| <b>SUBJECT</b>     | FOR APPROVAL: Planning Proposal and draft Development Control Plan for land at 197 and 207 Church Street and 89 Marsden Street, Parramatta |
| <b>REFERENCE</b>   | RZ/4/2015 - D07358670  |
| <b>REPORT OF</b>   | Project Officer Land Use   |

**Figure 7: Pedestrian Arcades – Applicant's preference shown with blue arrow (Option A); Council officer's preference shown with red arrow (Option B). Arrow shown with black dashed line is the through site link agreed by both parties.**

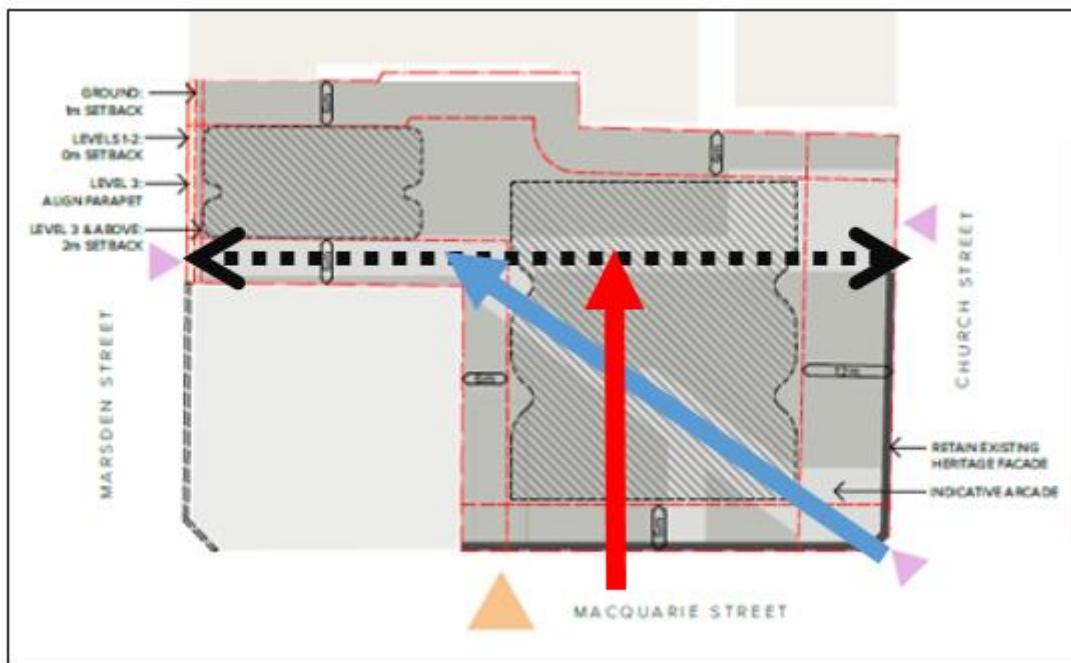
35. A key change that Council Officers are recommending to the Applicant's draft DCP is to the pedestrian access through-site link proposed by the applicant at the corner of Church and Macquarie Streets. This has implications for a number of sections of the draft DCP, and resulting changes are reflected in the recommended changes to DCP controls contained in **Attachment 5**.
36. The diagram below shows two potential locations of the main entry point from Macquarie Street and path of travel through the site connecting to the through site-link from Church Street to Marsden Street. The Applicant's preference is shown with a blue arrow (Option A), while Council officer's preference is shown with a red arrow (Option B).

37. Council's Urban Design officers recommend that the pedestrian access point should instead be on Macquarie Street (red arrow) for the following reasons:

- a. A preference for a 'solid' corner to help define the intersection at Church and Macquarie Streets, as well as the northwest corner of Centenary Square.

- b. To integrate with the existing and future network of laneways in the CBD, most importantly the future lane proposed to run north-south along the edge of the Planning Proposal at St John's Cathedral.

- c. The majority of the design competition submissions showed a pedestrian access to the site on Macquarie Street, rather than at the corner of Macquarie and Church Streets.

39. Council's Land Use Planning Officers note that both cases have elements that suggest they can be supported and that neither option is necessarily unacceptable. However, for the sake of clarity only one option should be included in the draft DCP. Land Use Planning Officers recommend Option B (red arrow in figure 7) be included in the DCP for the following reasons:

- a. Council has already identified a new pedestrian link running north-south along the western edge of the St John's Cathedral site opposite this site across Macquarie St. The north-south link illustrated in Figure 7 will align better with this new link.

- b. The Applicant's argument is that that the critical desire line is the pedestrian desire line for people moving between the Parramatta Square/Centenary Square/ Station Precinct and areas on Marsden Street to the northwest. It is considered that the link proposed still adequately address these desire lines.

- c. The Applicant's claim that the north south link location is fixed is based on the reference design and the location of a service core. The reference design is not the final design and the site will still be subject to a design competition process where the service core and location of the through site link can be resolved in more detail to address the applicant's concerns.

- d. The Urban Design team's conclusion that Option B provides a more defined corner element.

Figure 8: Recommended amended diagram for insertion in DCP – Traffic and Transport section

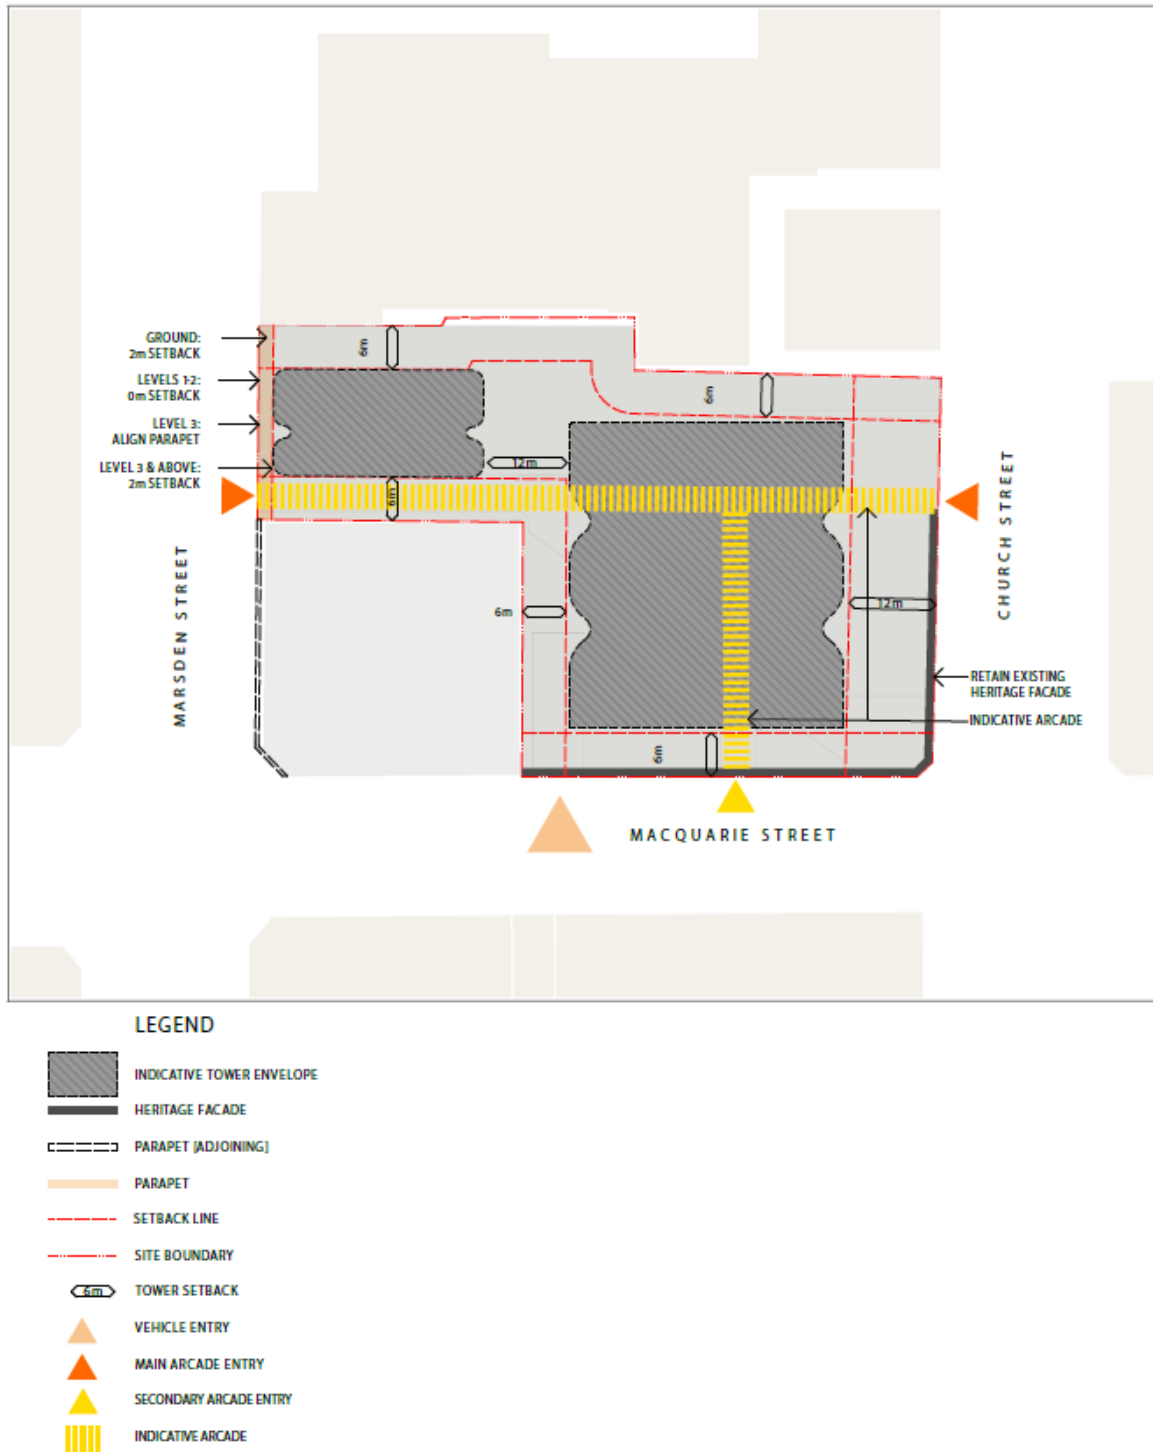
44. Second, the Applicant's draft DCP refers to existing parking controls that are not consistent with the Gateway Determination and are not recommended to be included in this Planning Proposal. Therefore, it is recommended that the reference to existing parking controls be removed.
45. Third, this section of the Applicant's draft DCP contains a key diagram which shows the layout of the site, including tower locations, setbacks, vehicular and pedestrian access points, etc. Council Officers are recommending changes to this diagram to reflect the key change to pedestrian entry point above, as well as to accord with the setback controls otherwise discussed in **Attachment 5** (Item 3). A copy of this diagram is included below.
